# Access Compliance Report

## Public Rights-of-Way

### (Curb Ramps)

Intersection ID: 12305	Main Street: E_5TH_ST	Cross Street: N_COLLEGE_ST	Location: N
ADA ID: 615F90202753	Ramp Type: PerpDiag	Initial Pass/Fail: Fail	Overall Compliance: No
			Severity Score: 33.75

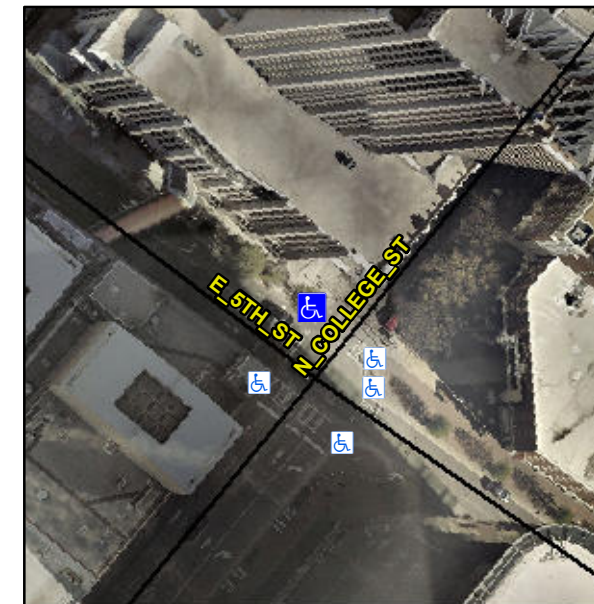
**R304.5.1, R304.2.2, R304.5.3**

Compliance	Description	Data	Compliance	Description	Data
N/A	Ramp Length (in)	51.0	No	Ramp Slope (%)	10.0
No	Ramp Width (in)	36.0	No	Ramp XSlope (%)	6.2
N/A	Flare Type LT	N/A	N/A	Flare Type RT	N/A
N/A	Flare Slope LT (%)	N/A	N/A	Flare Slope RT (%)	N/A
N/A	Flare Traversable LT?	N/A	N/A	Flare Traversable RT?	N/A
N/A	Landing Length (in)	N/A	N/A	DWS Provided?	N/A
N/A	Landing Width (in)	N/A	N/A	DWS Contrast?	N/A
N/A	Landing Slope (%)	N/A	N/A	DWS Length (in)	N/A
N/A	Landing X Slope (%)	N/A	N/A	DWS Full Width?	N/A
N/A	Landing Curb? (Y/N)	N/A	N/A	DWS Offset (in)	N/A
N/A	Shared Landing?	N/A			
N/A	Gutter Ponding?	N/A	N/A	Gutter Slope (%)	N/A
N/A	Gutter Lip Ht (in)	N/A	N/A	Gutter X Slope (%)	N/A
N/A	Painted X Walk1?	Yes	N/A	Painted X Walk2?	Yes
	X Walk 1 Direction	To SW		X Walk 2 Direction	To SE
N/A	X Walk 1 Width (in)	115.0	N/A	X Walk 2 Width (in)	112.0
	X Walk 1 Slope (%)	1.5		X Walk 2 Slope (%)	0.1
	X Walk 1 X Slope (%)	3.5		X Walk 2 X Slope (%)	4.0

N/A	Ramp inside XWalk1?	Yes	N/A	Ramp inside XWalk2?	Yes
	Road Slope (%)	4.6	N/A	Clear Space?	N/A
	Road X Slope (%)	3.5	N/A	Clear Space to XWalk (in)	N/A
N/A	Any Obstructions?	N/A	N/A	Storm Grate/Utility Hazard?	N/A
	Obstruction Type			Storm Grate/Utility Type	
		N/A			N/A
		Yes		Surface Condition? (G/P)	Good

**Remove & Replace Curb Ramp With Two New Directional Ramps or Equivalent.**
